04-AMCP-0398

APPROVAL REQUEST FOR K BASIN INTERIM REMEDIAL ACTION DESIGN CHANGES FOR HOSE-IN-HOSE TRANSFER AND K WEST SLUDGE CONSOLIDATION CONTAINERS

**Remedial Design Report Change Description for:**

1. **K East to K West Transfer System**
2. **K West Underwater Sludge Consolidation System**
3. **K West Sludge Pumping System**

**Site Plan Hose In Hose Transfer – East to West**
**Figure 1**

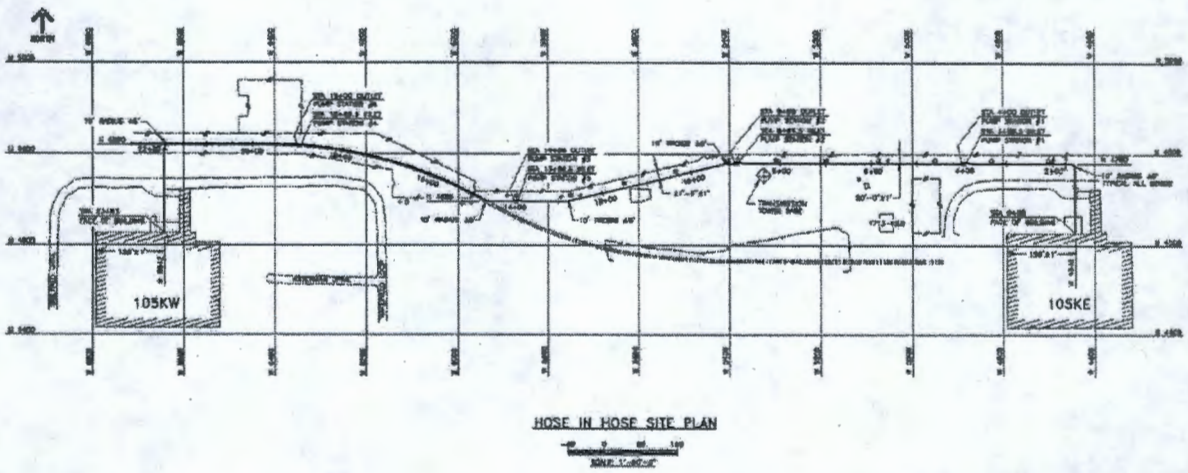
- Transfer the K East Basin sludge to K West Basin via a hose-in-hose transfer line (HIHTL)

The site plan, shown in Figure 1, provides the relative locations of systems and equipment in the K East Basin, the K West Basin, and the HIHTL between the basins.

**K-East General Arrangement**
**Hose In Hose Transfer - East to West**
Figure 2

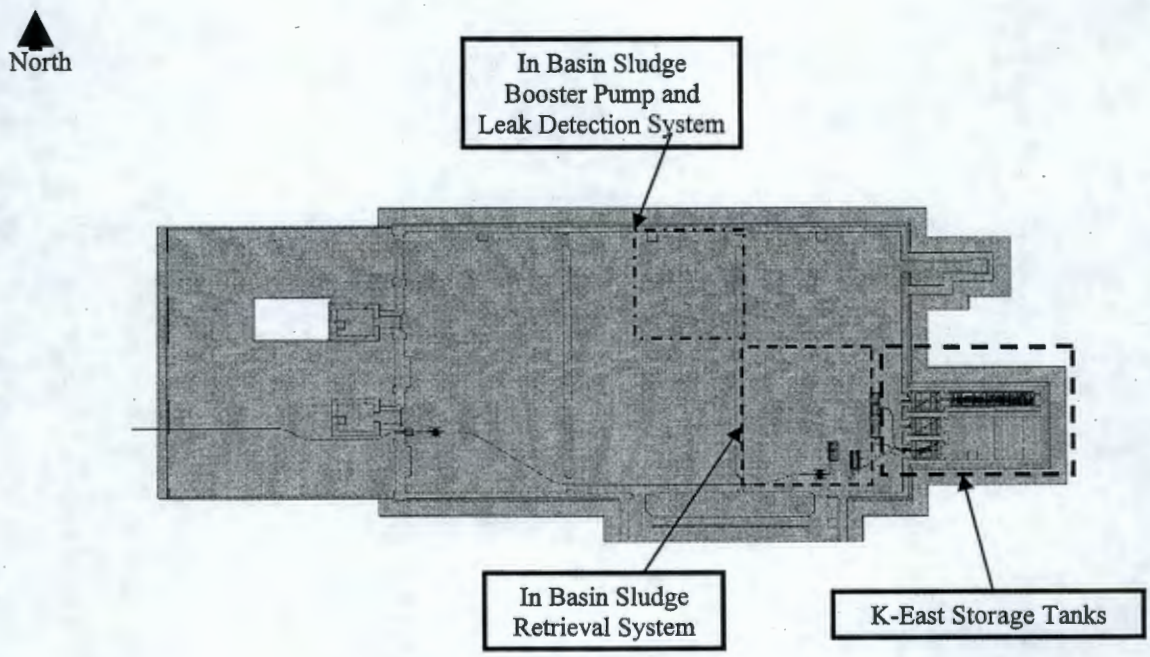
The four K East Basin consolidation containers (labeled storage tanks) are located in the weasel pit, the entrance to the weasel pit, and the two entrances to the tech view pit on the east end of the K East Basin. The in-basin sludge retrieval system equipment is situated in the east bay of the K East Basin, directly adjacent to the weasel and tech view pits.

Retrieved sludge is transferred via hose and it is pumped through a leak detection box just above the surface of the pool water. The transfer hose from the retrieval system is joined to the HIHTL in this box, which is provided with leak detection equipment. The sludge is then transported to the K West Basin via the HIHTL

**K East Sludge Retrieval System**
**Sludge Retrieval from a Tech View Container**
**Figure 3**

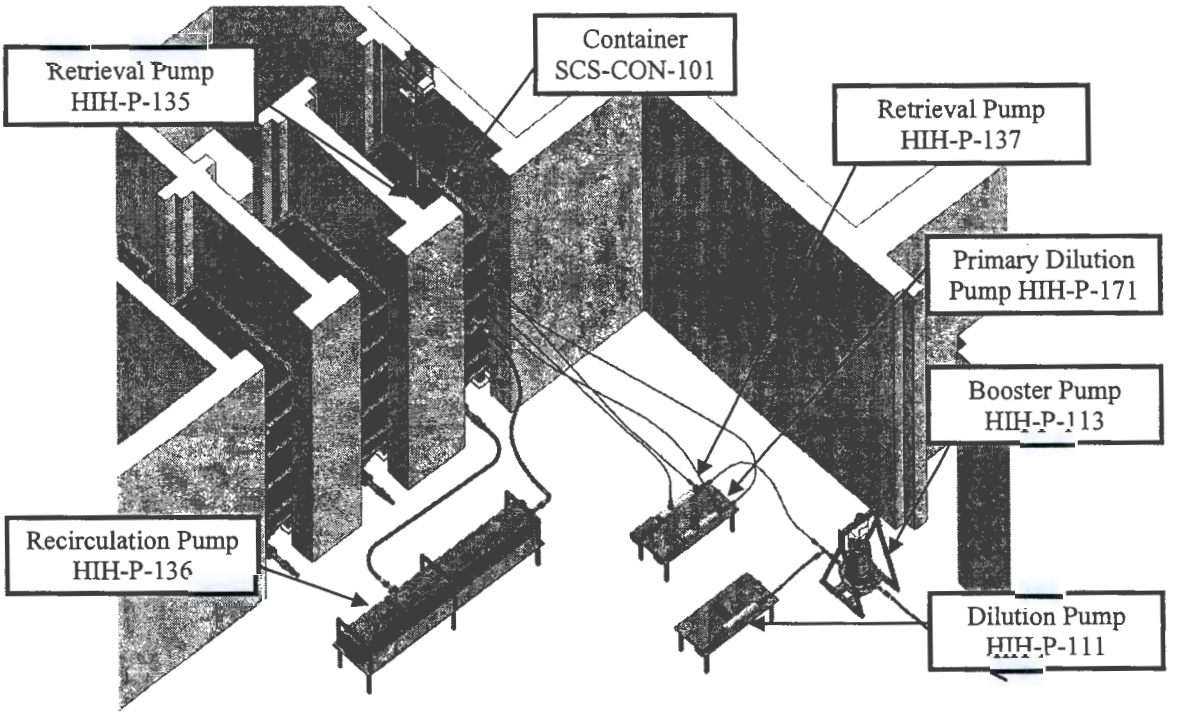
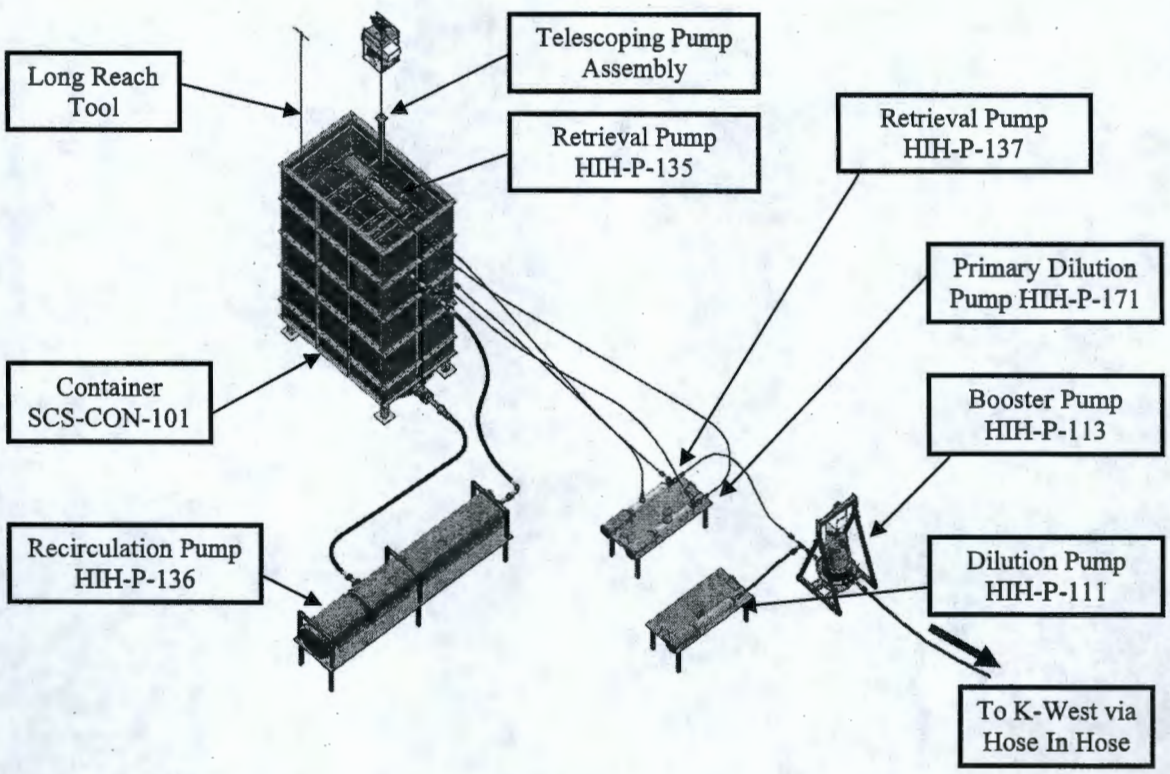
The K East Basin sludge retrieval system includes equipment designed to retrieve sludge from the connection at the bottom of the consolidation containers as well as equipment to retrieve sludge through the top of the containers. Sludge retrieval will be done using either or both of these systems as needed to complete container cleanout.

Sludge will be retrieved from all four consolidation tanks. Because the largest container, is located behind one of the smaller containers, retrieval from that container is slightly different from the other three containers. See the following figures for illustrations.

**K East Sludge Retrieval Sludge Transport to K West – Hose-in-Hose**
**Figure 5**

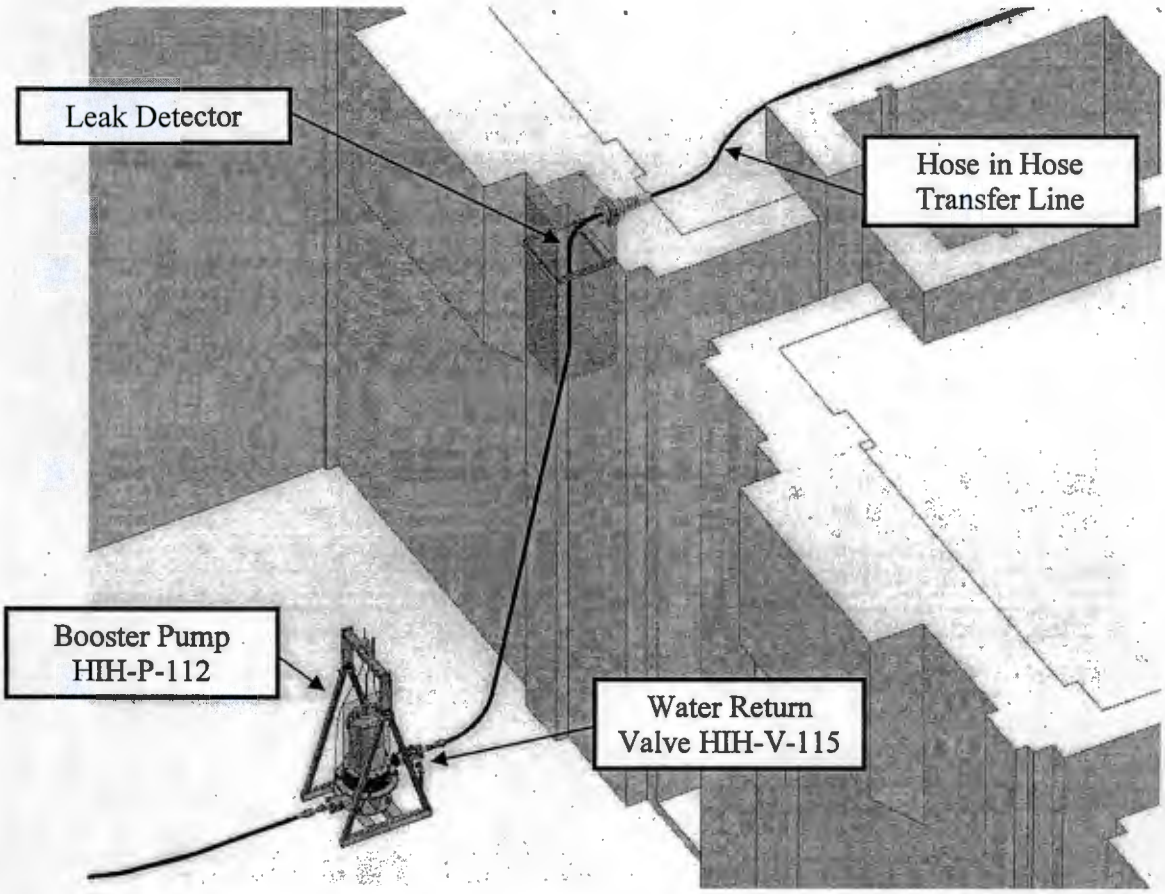
Figure 5 shows the sludge retrieval hose as it leaves the basin water and connects to the HIHTL.

After the sludge is diluted, it flows through a booster pump. Prior to leaving the pool, the sludge slurry enters a booster pump. This pump moves the slurry to the water surface where the retrieval hose is coupled to the HIHTL.

The connection point for the retrieval hose and the HIHTL is housed in a metal enclosure, which is equipped with leak detection instrumentation.

Figure 5 provides a view of the leak detection system used at the retrieval hose – HIHTL connection point in K East.

**Hose-In-Hose Cross Section**
**Figure 6**

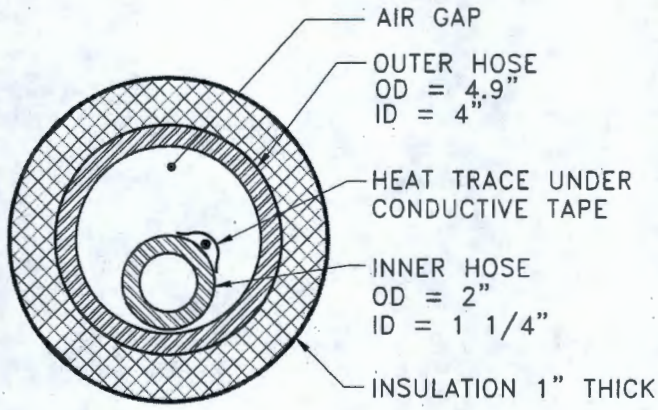
Figure 6 shows a cross section through the hose-in-hose line.

The inner hose, through which the sludge slurry travels, has an inner diameter of 1.25 inches and an outer diameter of two inches. The inner hose is also wrapped with heat trace wire for the purpose of freeze protection.

The inner hose lies on the bottom of the outer hose. The annular space between the inner and outer hoses is filled with air, which is open at both ends.

The outer hose has an inner diameter of four inches and an outer diameter of 4.9 inches. It is surrounded by a one-inch thick layer of insulation.

Both hoses are made of EPDM material. They are double reinforced for load rating. These hoses are expected to be the same as the hoses used at Hanford for Tank Farm waste transfers except for the diameter of the hoses.

**K West General Arrangement**
**Figure 7**

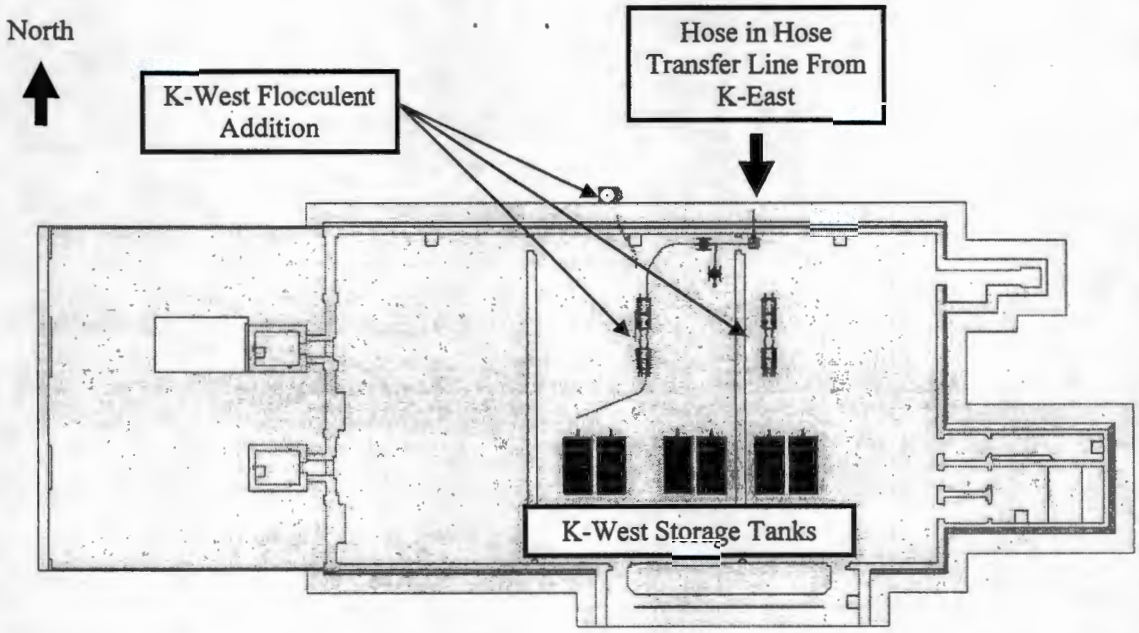
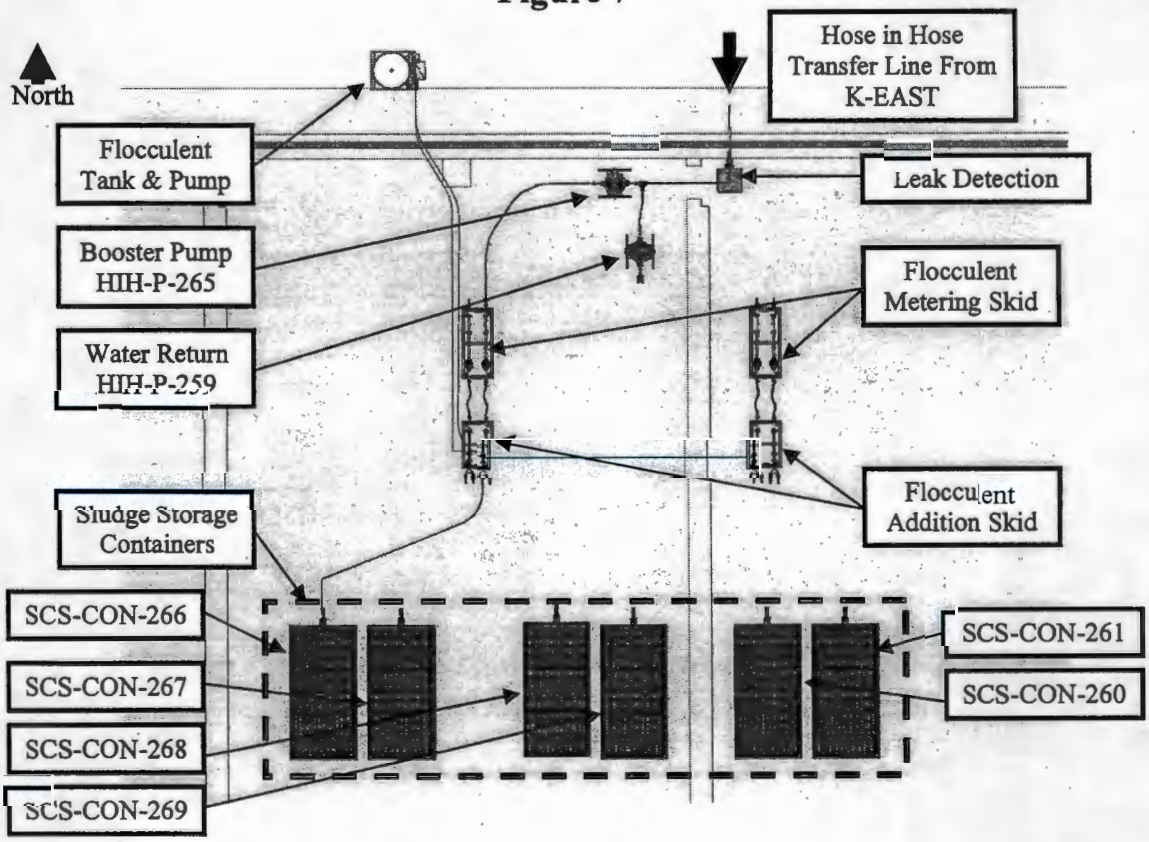
Figure 7 shows the general arrangement of sludge transfer and storage equipment within the K West Basin. The subsequent figure focuses specifically on the center and east bays, where the sludge transfer and storage equipment is located.

The HIHTL enters the K West Basin and connects with the sludge hose used to transport the sludge to the underwater storage containers in a leak detection box identical to the one previously described for sludge leaving the basin water in K East Basin.

Once the hose has entered the basin pool, a booster pump moves the sludge through a flocculent metering skid. Note that there may be two identical skids: one in the center bay and one in the east bay.

The flocculent metering skid contains a meter that determines the amount of flocculent to be added at the flocculent addition skid. Flocculent is pumped to the addition skid from the flocculent tank located at the side of the basin.

The flocculated sludge is then routed to one of the sludge storage containers in the center bay or in the east bay.

In addition to showing the general arrangement for sludge receipt and storage, the next two figures also show the equipment used for return of basin water to the K East Basin.

The HIHTL is also used for basin water return. When water is to be returned, a valve just before the final sludge booster pump is positioned to allow basin water to enter the HIHTL.

**K West Sludge Storage Container**
**Figure 9**

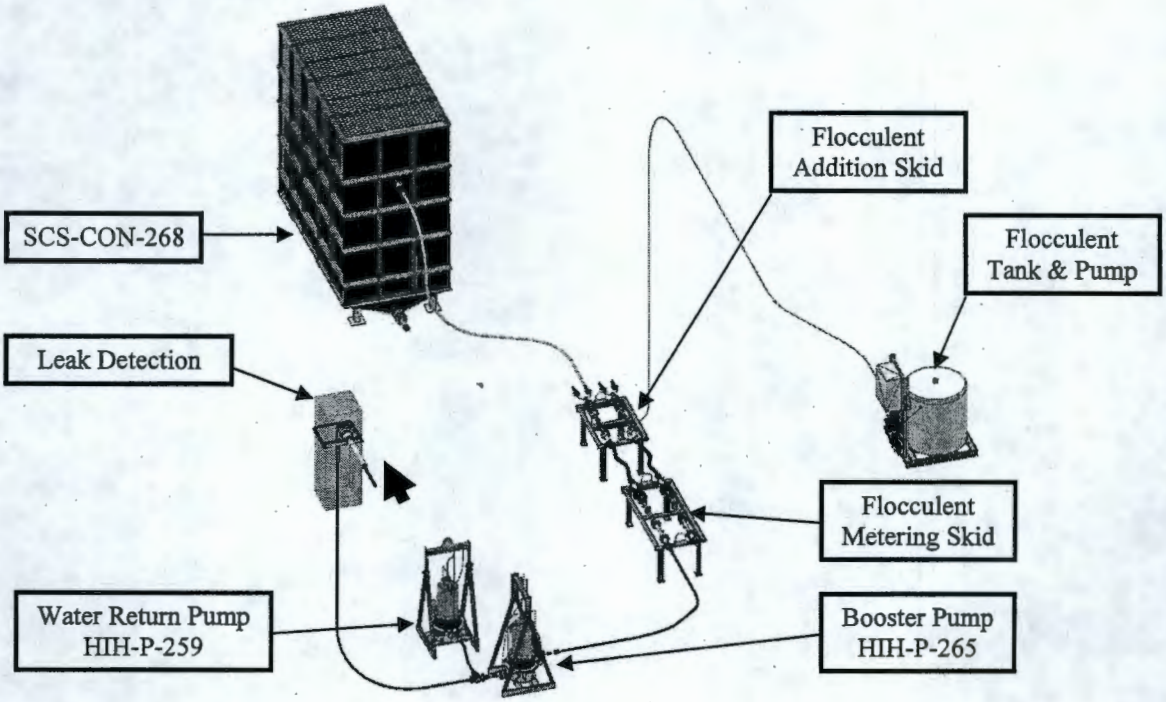
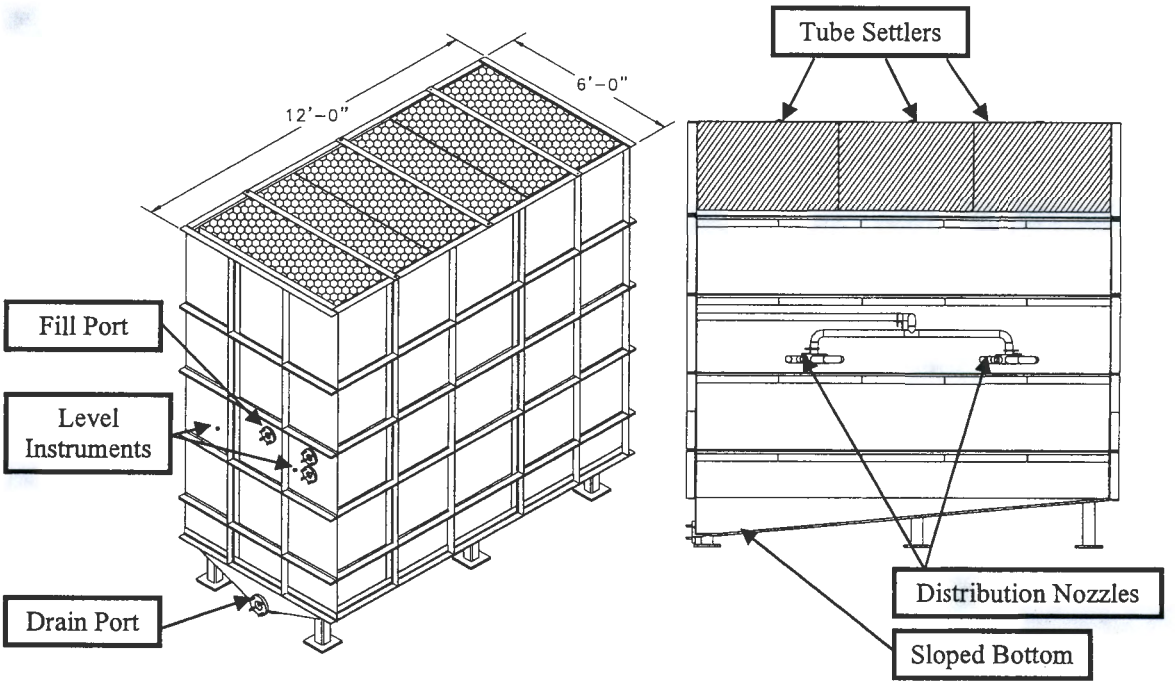
Figure 9 shows the system for sludge receipt and storage in K West Basin. For the K West Basin storage container, the basin walls have been omitted so that the system can be seen more easily.

The storage containers in K West Basin have different dimensions than those in the K East Basin, but they have the same basic design.

The sludge containers in the K West Basin are shorter than those in K East Basin to preclude the need to add any supplemental shielding beyond that provided by the basin water.

Sludge is collected in the open-topped, free-standing stainless steel container. Container bottoms are sloped to aid in the future retrieval of the sludge from storage.

Sludge enters the container through the header and is distributed to the container via slurry distribution nozzles. The purpose of this distributor is to symmetrically disperse the flow from the header so that the resulting upward fluid velocity is controlled.

The heavier sludge particles settle out quickly. Settling of the lighter sludge particles is enhanced by the inclined tube settlers installed in the top section of the container. The tube settlers are open–ended tubes arranged in a honeycomb pattern. Sludge collects on the lower surfaces of each tube and filters down the tubes to settle on the bottom of the containers.

Clear water is returned to the basin by flowing over the top of the container.

**Figure 11**

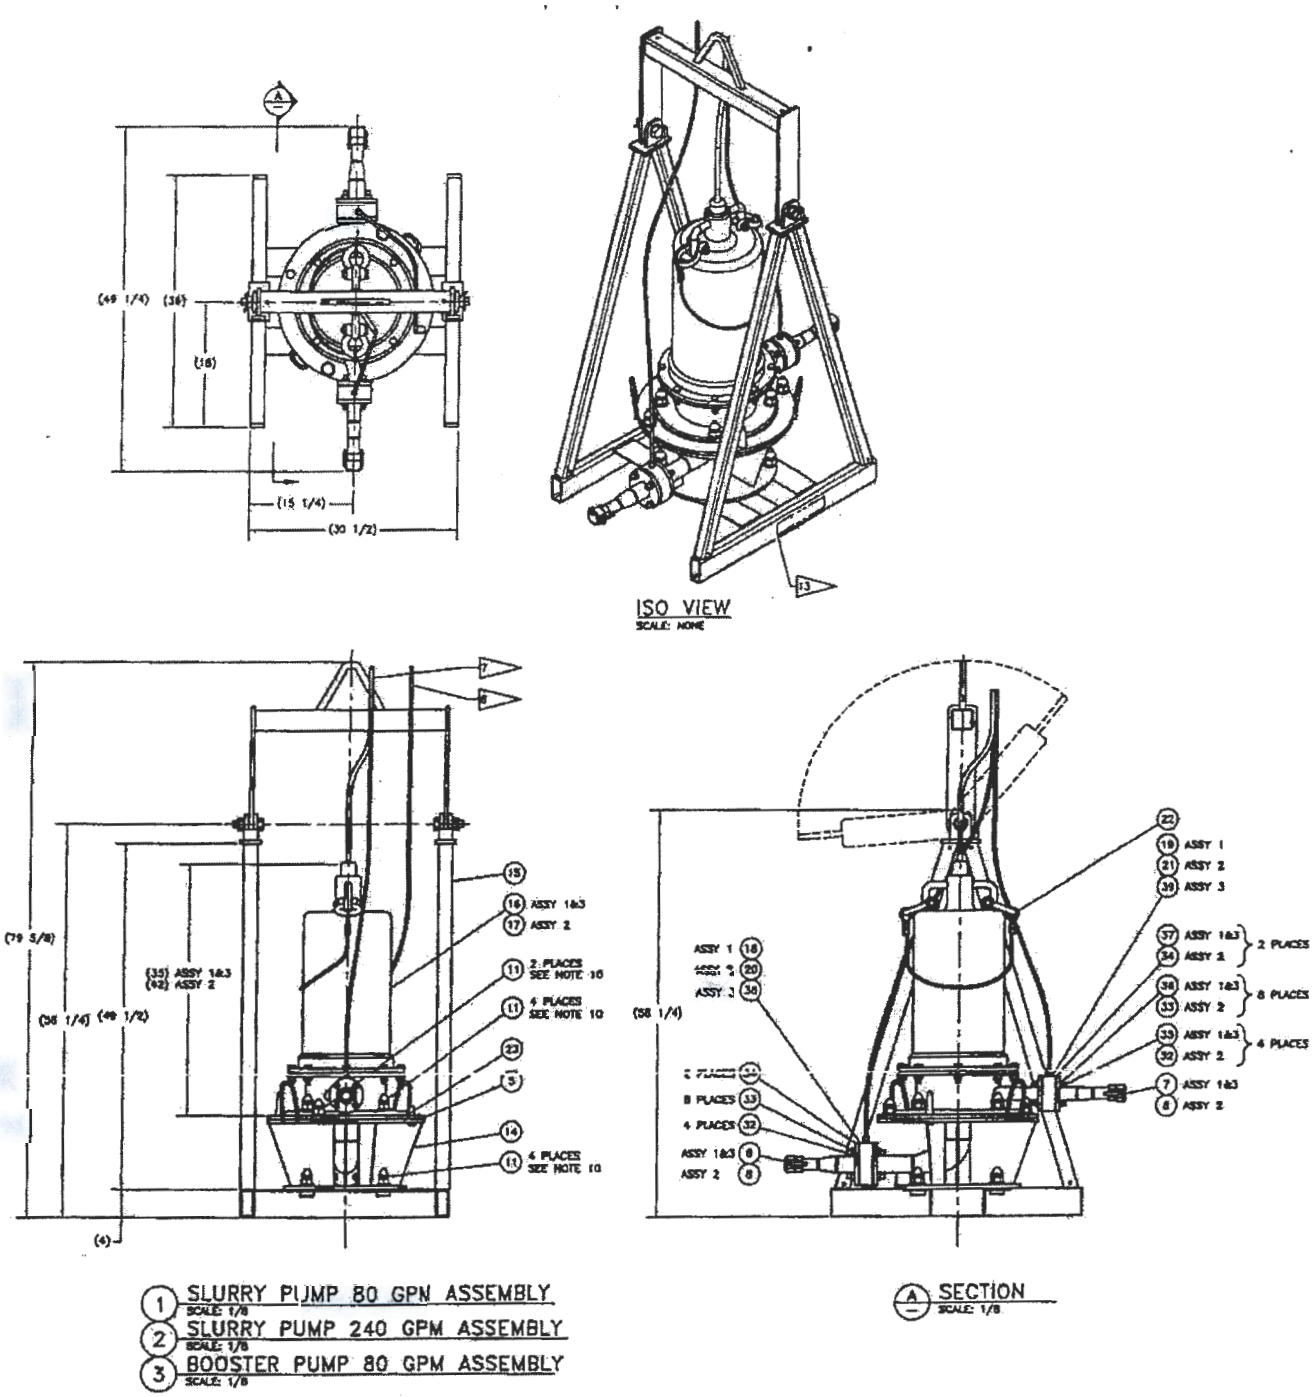
The K West Basin sludge pumping system includes equipment designed to retrieve floor and pit sludge in the basin and transfer that sludge to either the sludge consolidation containers (Figures 8, 10) or the Integrated Water Treatment System (Figure 13) in the case of retrieving sludge in the west bay of K West Basin.

- Pump skids (Figure 11)
- Suction wand (Figure 12)
- Tie in to IWTS (Figure 14)
- Sludge consolidation containers in K West Basin for K East and K West Basins sludge (Figure 10)
